BID ADDENDUM NO. 1

Date of Addendum: December 23, 2021
Issued for Bid Date: December 10, 2021
Client Name: Eastchester Union Free School District
Project Name: 2021-2022 Middle School Gymnasium Renovations and Roof Replacements
SED Project No.: Eastchester High School: 66-03-01-03-0-003-028
MEMASI Project No.: 102-2103
Contracts: Contract 1: General Construction Contract 01
Contract 2: Mechanical Contract
Contract 3: Electrical Contract

SPOT FOR ROOF COMPOSITION OF ROOF CC & DD

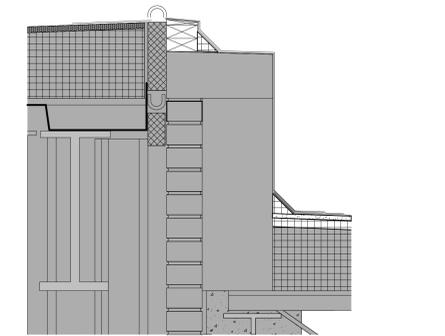
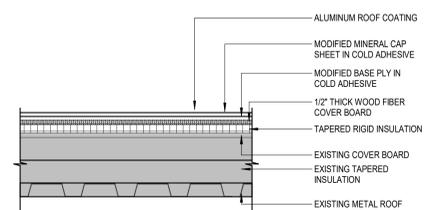
Please confirm note #1 on drawing MS SD 100 for removal and replacement of the entire area of metal decking.

Existing deck on roofs CC and DD will be removed and replaced with new metal deck.
See note D9 on AD102 - Remove existing "Porex" deck replace with new metal deck.
